SDW Public Meeting
Jan 13, 1984

OF NRC/CPCO/BECHTEL ETC
MIDLAND ON 1/4/82.

CONSUMERS POWER COMPANY
MIDLAND PLANT UNITS 1 & 2

MIDLAND PROJECT
RESIDENT ENGINEER MEMORANDUM

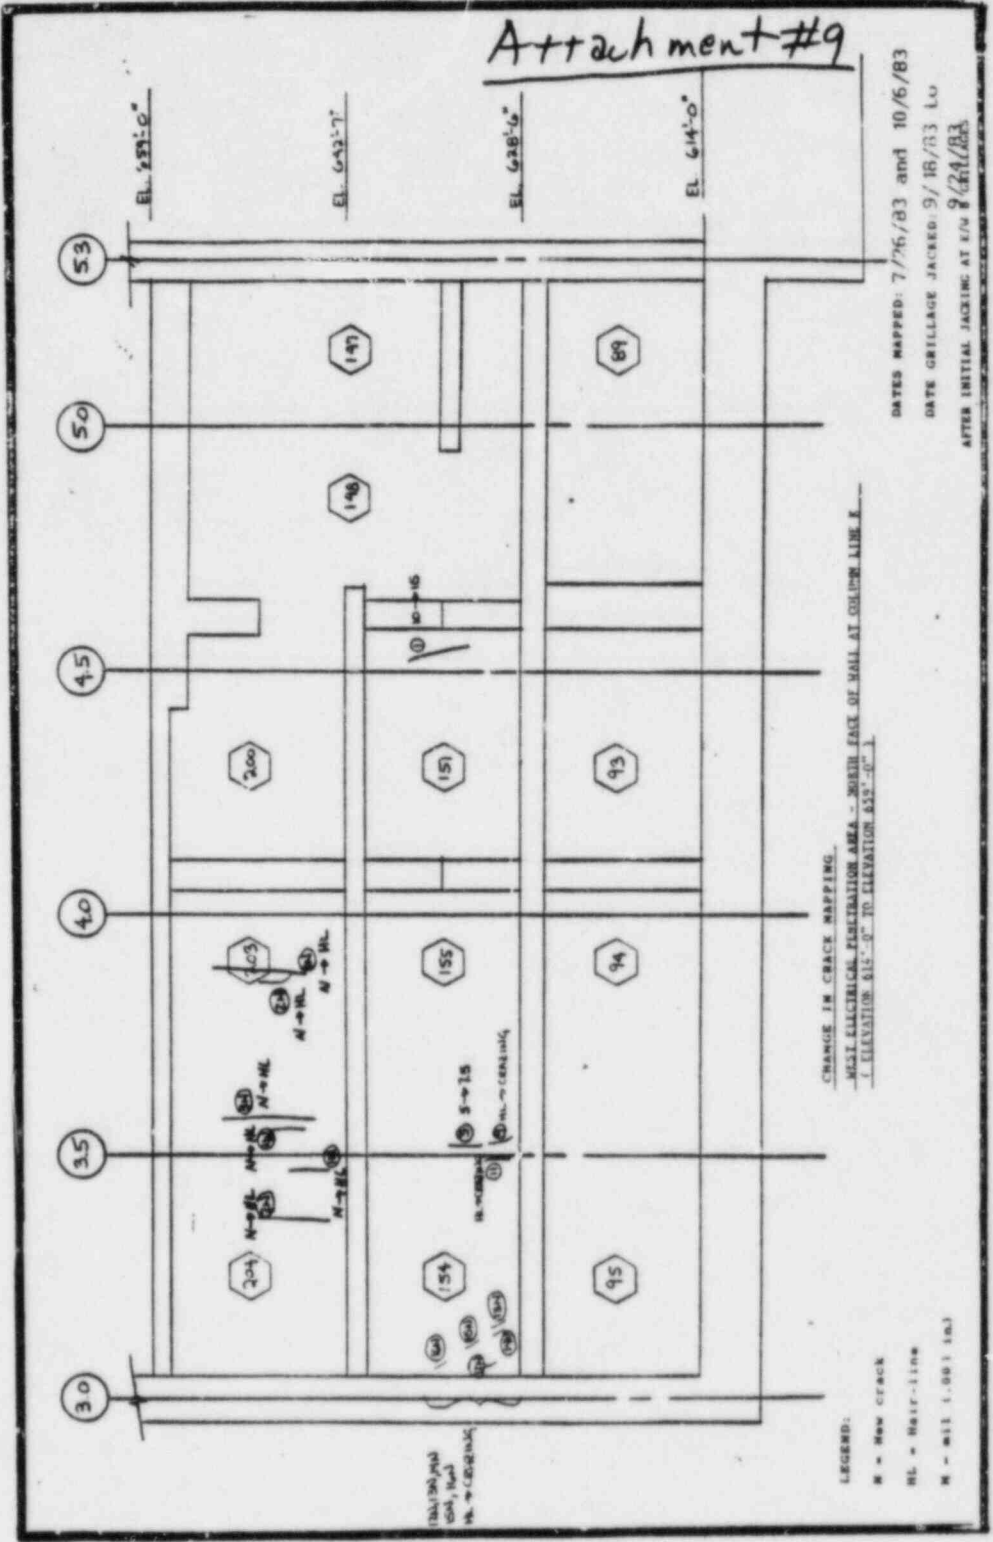
THE ANALYSIS OF THE EPA HAS SHOWN A 140 MIL DISPLACEMENT FOR 4000^K OF LOAD (UPLIFT). IT WAS INDICATED THAT THIS VALUE WAS CONSERVATIVE AND THAT A VALUE OF 160 MILS COULD BE UTILIZED. THIS LEADS TO A RELATIONSHIP OF 4 MILS DISPLACEMENT PER 100^K OF LOAD. THEREFORE WE WOULD HAVE THE FOLLOWING:

160 MILS Project Engineering Comment. VV 10-14-83

With Comments.

Comment altered. 11/8/83

DURING THE INITIAL JACKING OF THE GRILLAGE
AT W/B WE WILL UTILIZE THE FOLLOWING CRITERIA:

LIMIT	ACTION
30 MILS	DROP LOAD TO 80% OF MARL AS REQUIRED BY PROCEDURE BUT WE ARE CLEARED TO PROCEED
40 MILS	HOLD FOR 24 HRS AND EVALUATE BLDG MOVEMENTS
50 MILS	" " " " " "
60 MILS	HOLD LOAD AND EVALUATE

IF ANY LIMIT ABOVE 30 MILS IS REACHED DURING THE JACKING ANN ARBOR WOULD BE CONTACTED AND THE MOVEMENTS EVALUATED BEFORE PROCEEDING WITH THE JACKING.
